CAMP BULLIS ROAD 12-INCH WATER MAIN PROJECT

Solicitation No.: CO-00082-RA

Addendum 2 | July 22nd 2016

Addendum No. 2 - Attachment A - Revised: 7/22/2016

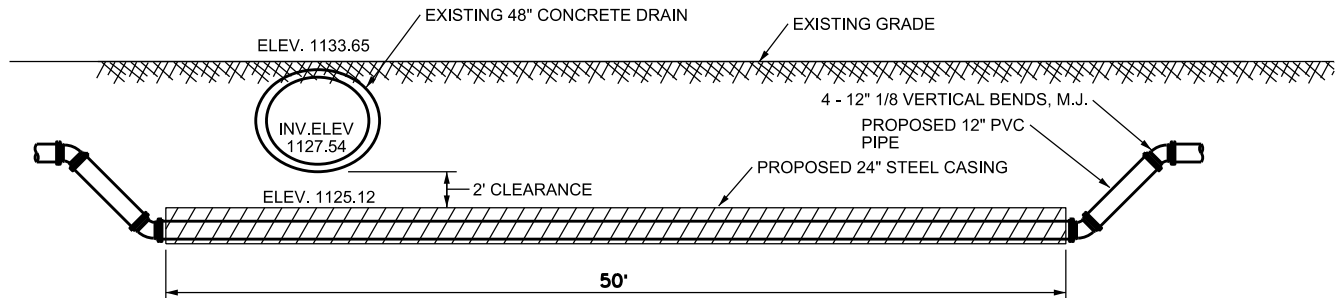
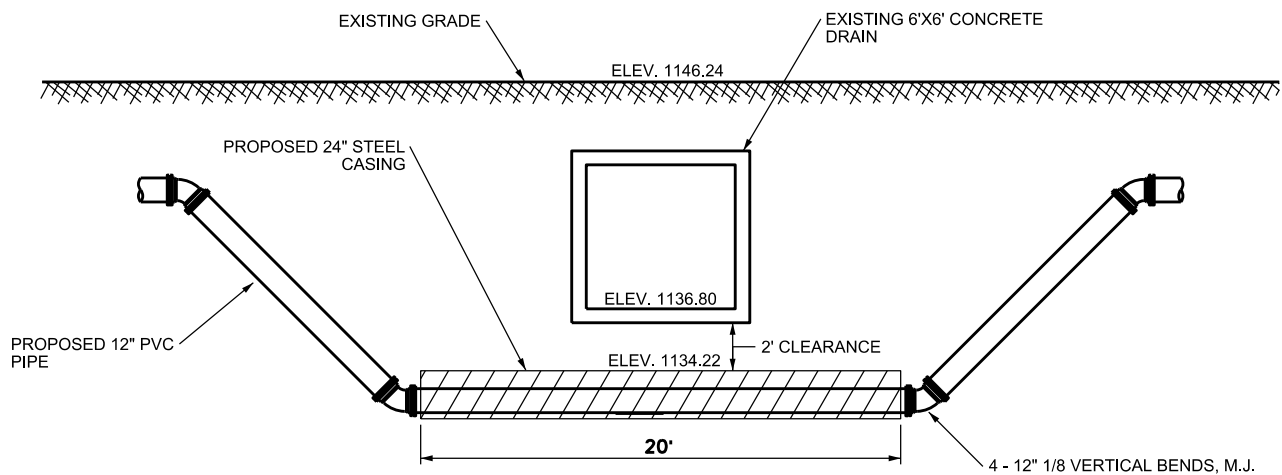
7. **Question:** Please furnish the bidders two profile sheets showing the offsets and their depth for the two proposed bores at stations 1+62 thru 2+12 and 12+52 thru 12+72. These areas are in rock and we cannot establish an accurate cost without knowing how deep we will be required to go.

Response: Profile diagrams are included as Attachment A of this addendum. These diagrams are for clarification only and should not be used for construction. Additional descriptions of the bores follows:

The bore beginning at station 1+62.21 will need to be deep enough to install the new 24" steel casing with 2' of clearance between the top of the new steel casing and the bottom of the existing Reinforced Concrete Pipe (RCP). The RCP has a total height of approximately 60". The difference between the elevation of the road and the top of the RCP is approximately 16". The minimum depth of the bore is approximately 10.5', but the final depth will be determined by the contractor.

Similarly, the bore beginning at station 12+52.20 will need to be deep enough to install the new 24" steel casing with 2' of clearance between the top of the steel casing and the bottom of the 6' X 6' Storm Drain Box. The difference between the elevation of the road and the top of the Storm Drain Box is approximately 30" so the minimum depth of the bore bit is approximately 12.5' but the final depth will be determined by the contractor.

TRAFFIC CONTROL PLAN
TRAFFIC SHIFTS ON
TWO LANE ROADS

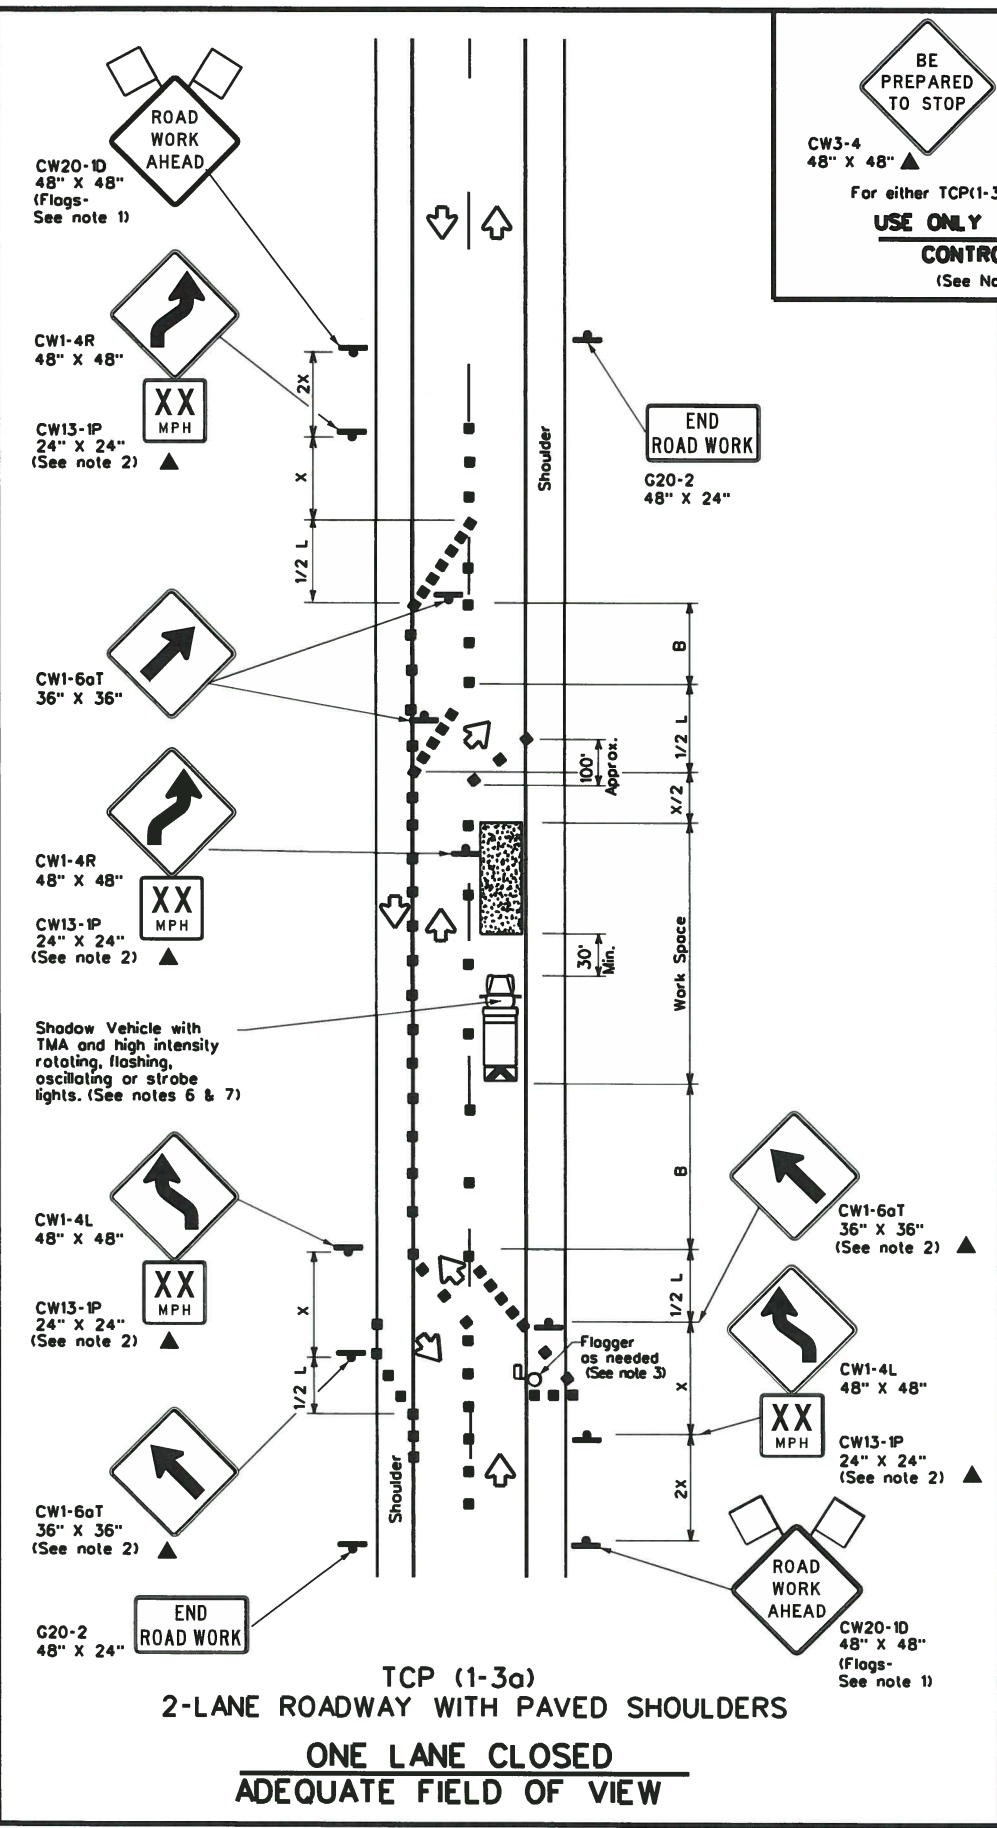
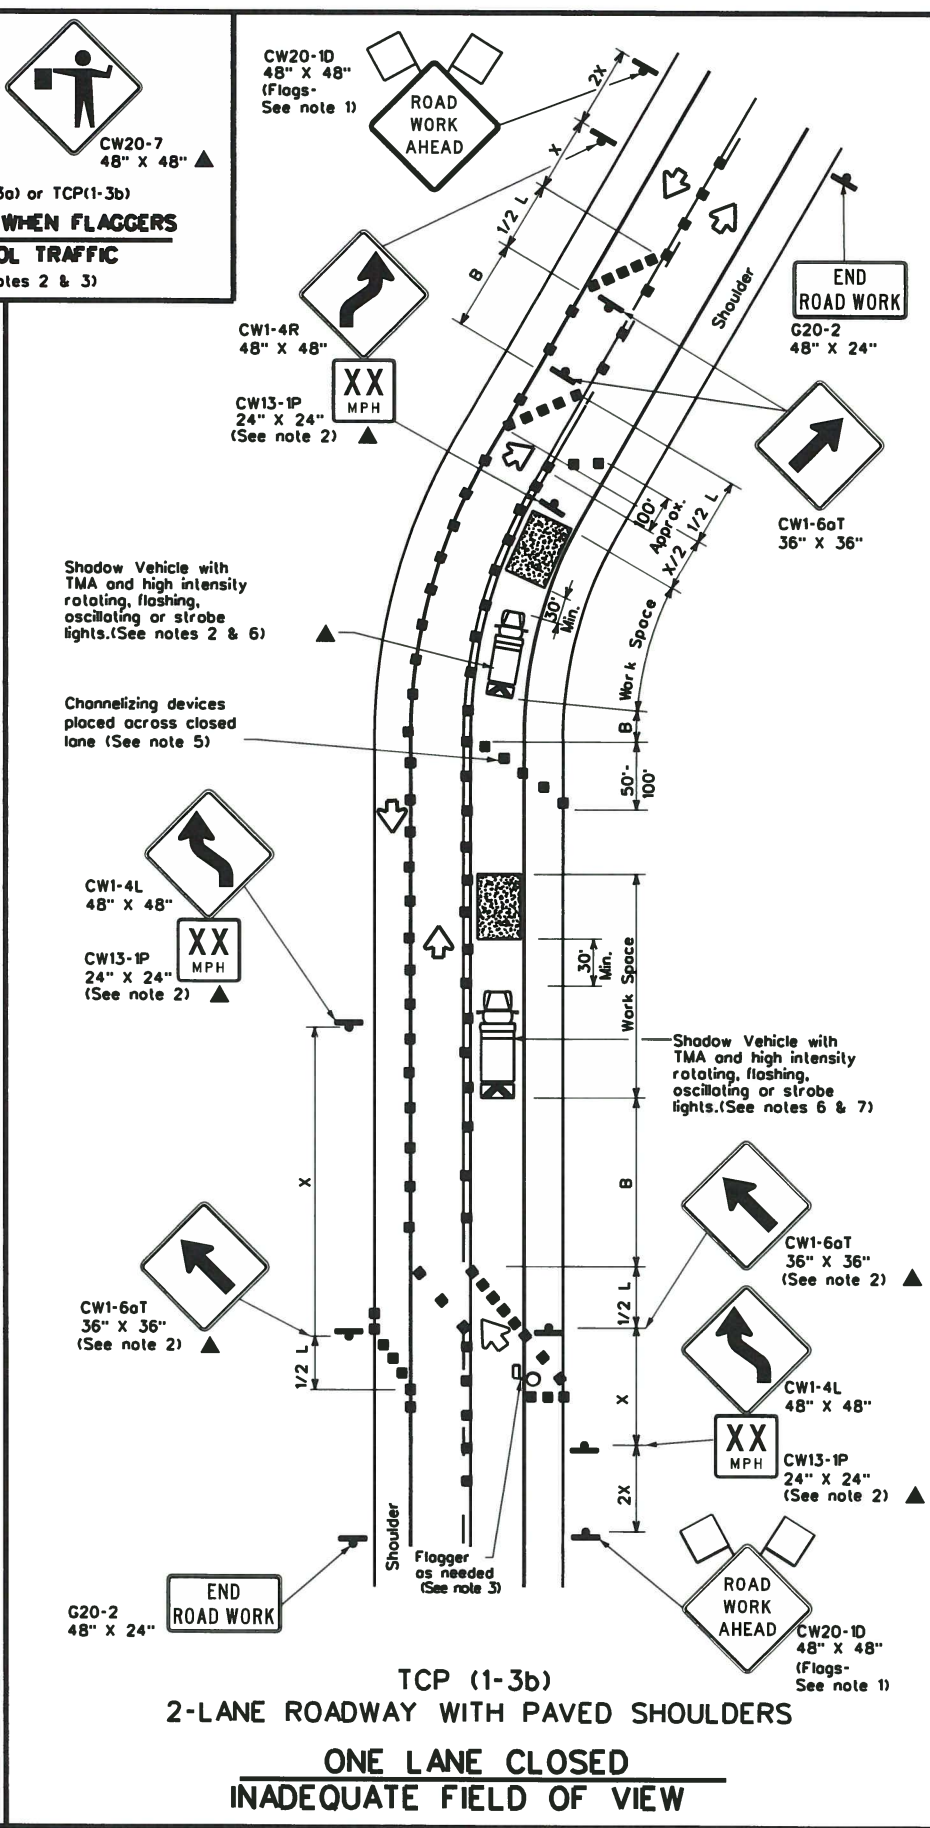
2. **Question:** The bore pit will have to remain open overnight. Will two-way traffic be shut down to just one-way traffic for this? If not, how will traffic be handled? Will concrete barriers be required?

1. Insert attached Traffic Control Drawing as sheet TC-4.

Response: The intent is for the road to remain accessible to two way traffic even as the bore pits are open. Drawings for the relevant Texas Department of Transportation traffic plan are included as Sheet TC 4 attached to this Addendum. The contractor will provide the necessary traffic control measures. Concrete barriers will be required near the bore pits for as long as they are open.
